Product Change Notification

108558 - 02

Change Notification #: 108558 - 02
Change Title: Intel(R) IP Network Server NSC2U, PCN 108558-02, Product Design, New retention mechanism for optical drive will replace the original mechanism, Reason for Revision: Update TA revision numbers
Date of Publication: January 12, 2009

Original optical drive retention mechanism shown on left.

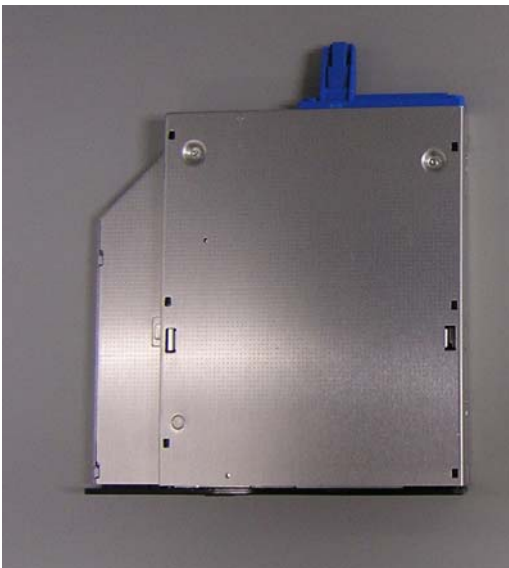
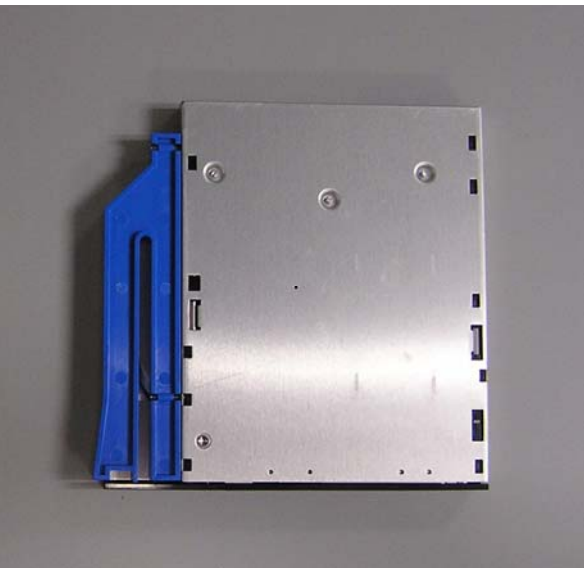
Intel has designed a new optical drive retention mechanism to simplify the installation and removal process of the CDROM drive. The revised retention mechanism allows removal and replacement without opening the top cover. The original mechanism will be discontinued and replaced by the revised mechanism.

Revised optical drive retention mechanism shown on right.

Revised optical drive retention mechanism attached to drive (underside of CDROM shown)

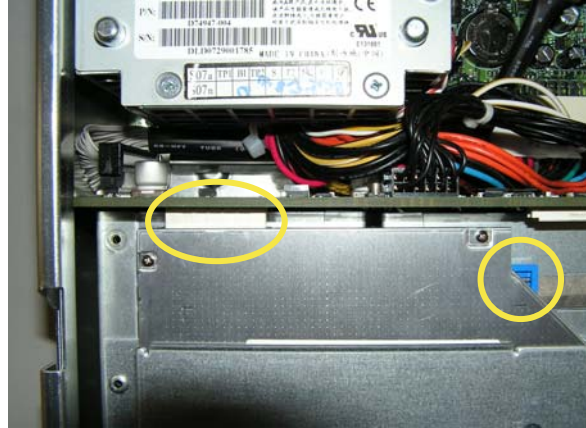
Original optical drive retention mechanism attached to drive (underside of CDROM shown)

Optical drive installed via original retention mechanism shown on left.

Optical drive installed via revised retention mechanism shown on right.

Optical drive can be removed by moving the lever to the left (see yellow arrow). The lever can be moved with a finger or general tool (like a screwdriver).
